IFB120543 Bartlett Reynolds Site Improvements

ADDENDUM NO. 1

BARTLETT / REYNOLDS SITE IMPROVEMENTS 113-261 BARTLETT ST ROCHESTER, N.Y. RHA Work Order #120543

PROJECT NUMBER
WO #120543 / AECOM #60503803
SHEET TITLE
CIVIL GRADING PLAN, SITE DETAILS & NOTES

32 12 16 – Asphalt Paving Pg. 3 of 3:

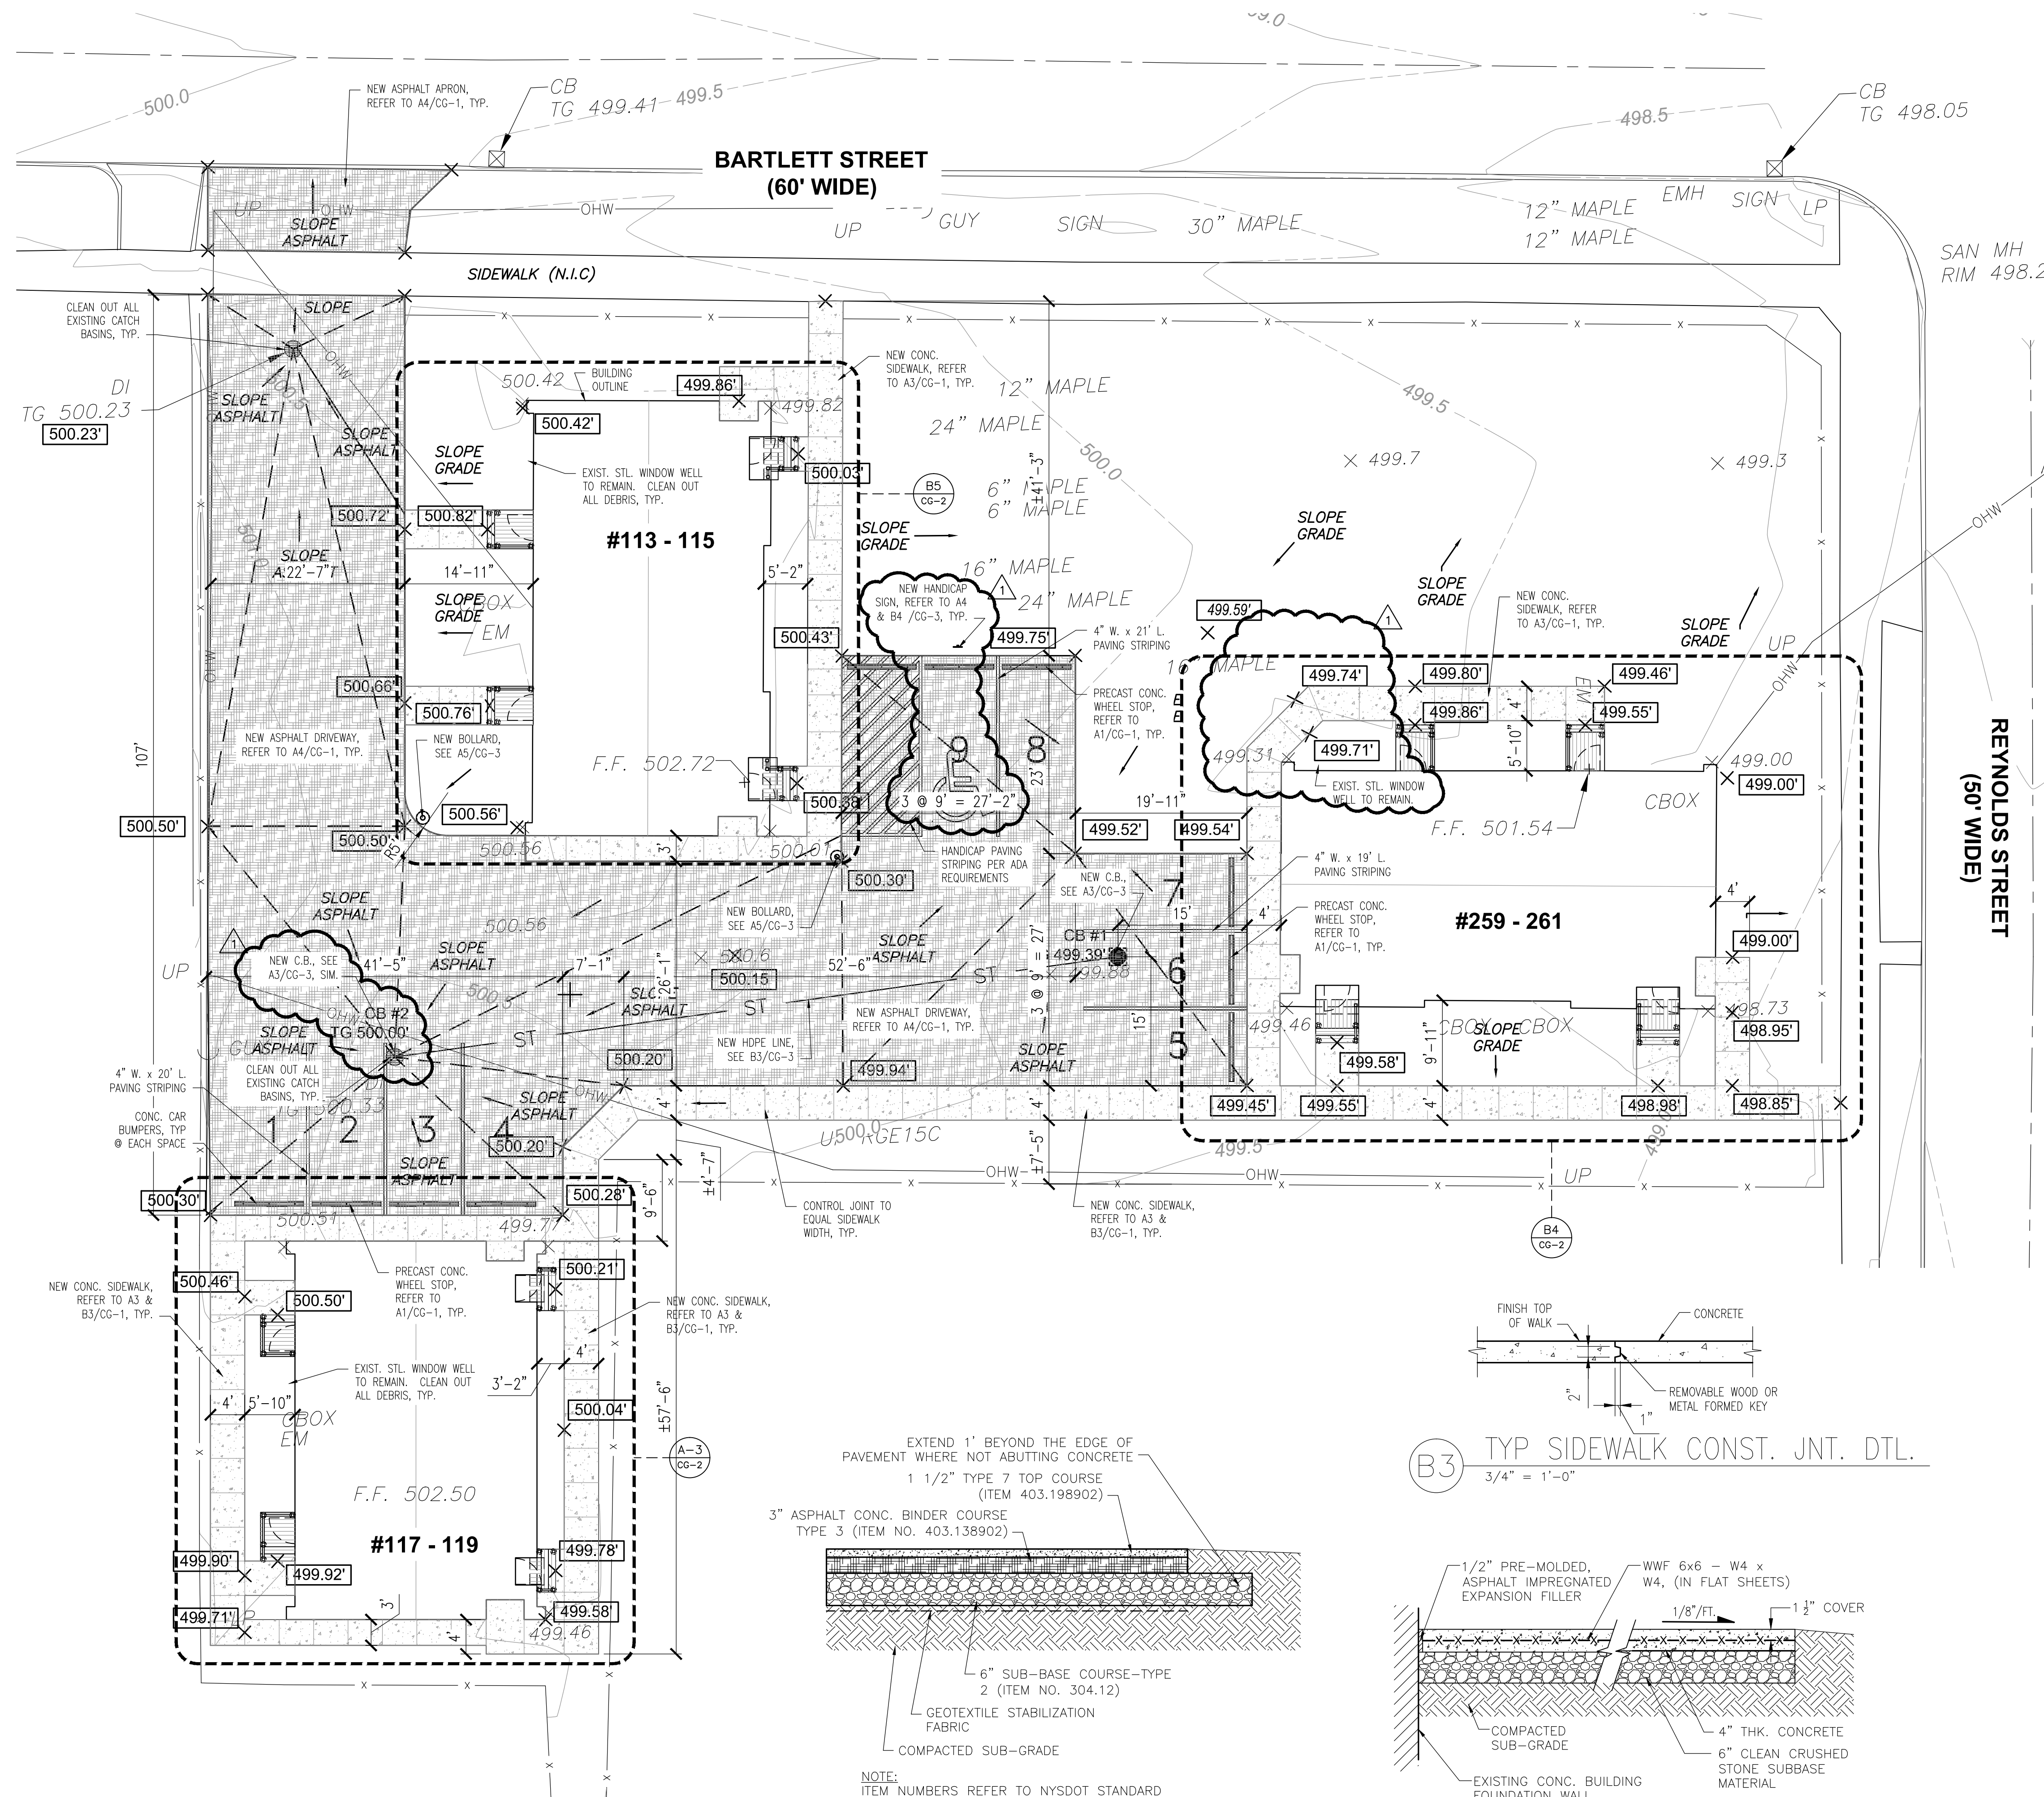
6. The header for page 3 for specification section 32 12 16 – Asphalt Paving shall read:

A5 CIVIL GRADING SITE PLAN
1' = 10'-0"

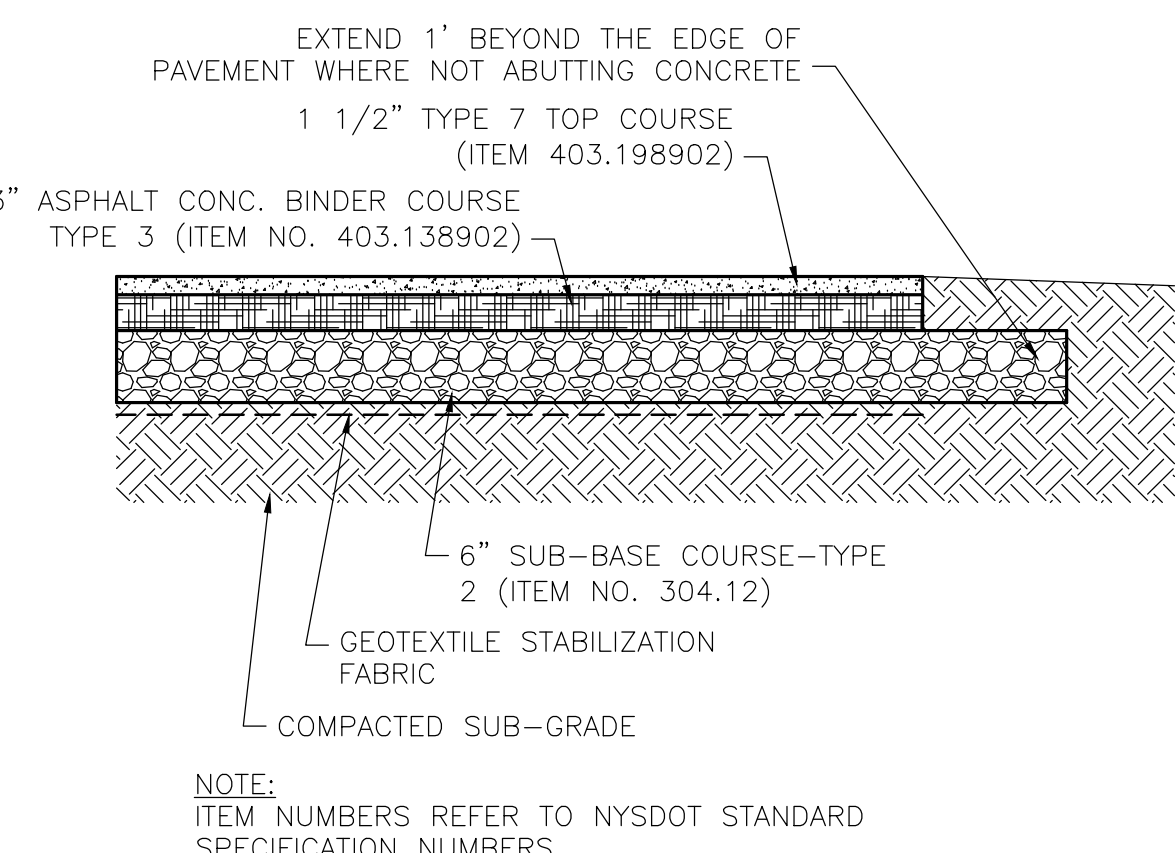
1. On drawing CG-1, the existing catch basin is to be replaced with a new catch basin. Refer to detail A3/CG-3, similar. See attached revised drawing CG-1.
2. On drawing CG-1, the ADA sign is to be moved to space #9. The ADA symbol is to be painted on this space. See attached revised drawing CG-1.
3. On drawing CG-1, the sidewalk by the northwest corner of unit #259-261 is to be moved south to avoid the existing maple tree. See attached revised drawing CG-1.
4. On drawing CG-1 the numbers on the parking spaces are for reference only. Do not paint the numbers on the spaces.
5. The Geotextile Stabilization Fabric noted on detail A4 on drawing CG-1 shall be one of the following acceptable Manufacturers:
 - a. Phillips Fibers Corp., SUPAC 4NP.
 - b. WEBTEC, Inc. Terra Tex SD.
 - c. DuPont, Typar 3401.
 - d. Mirafi, 140N.
 - e. Exxon Chemical Co., GTF-130D.
 - f. Or approved equal
